Title CHANNEL
 AMPLIFIER CARD
 Drg.No. T82241-71

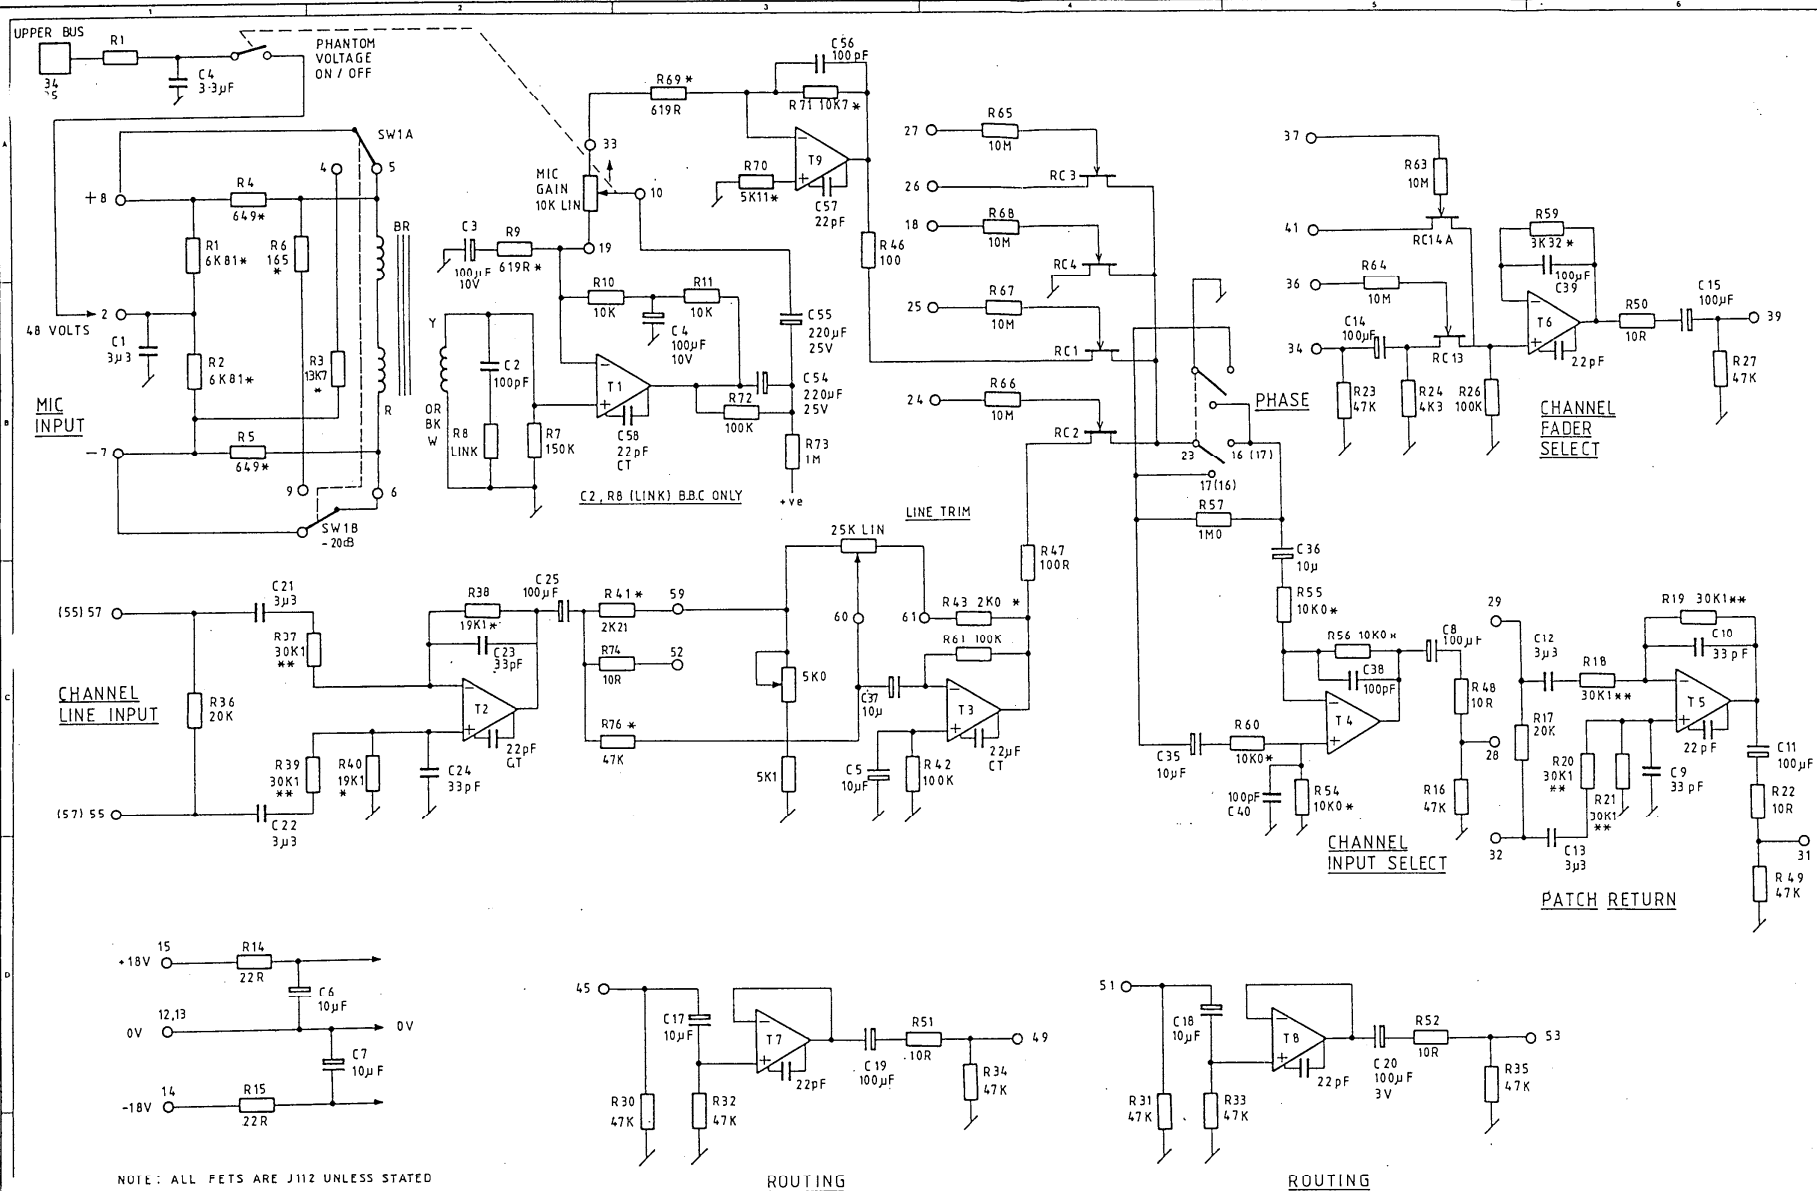
Rev.	Issue	Chkd	Details
15	q	1184	REURAWN U.U
15	b	JH Jan86	R58,R62 & RC14B DELETED
15	c	DTG Feb86	RC15 AMD TO RC13
15	d	Apr86	RENUMBERED WAS T82001.71. NOW T82241
16	a	DM May86	R74 10R ADDED
16	b	DTG June86	SW1A & 18 GANGED CON. AT 60.
16	c	May87	R59 & R63 CONNECTION REMOVED.
17	a	DM 30 July 87	R38 & R40 WERE 30 NOW 19K1. R41 WAS 3K01 NOW 2K21. R4 WAS 2K21 NOW 2K0. R76 ADDED. ECO 290E
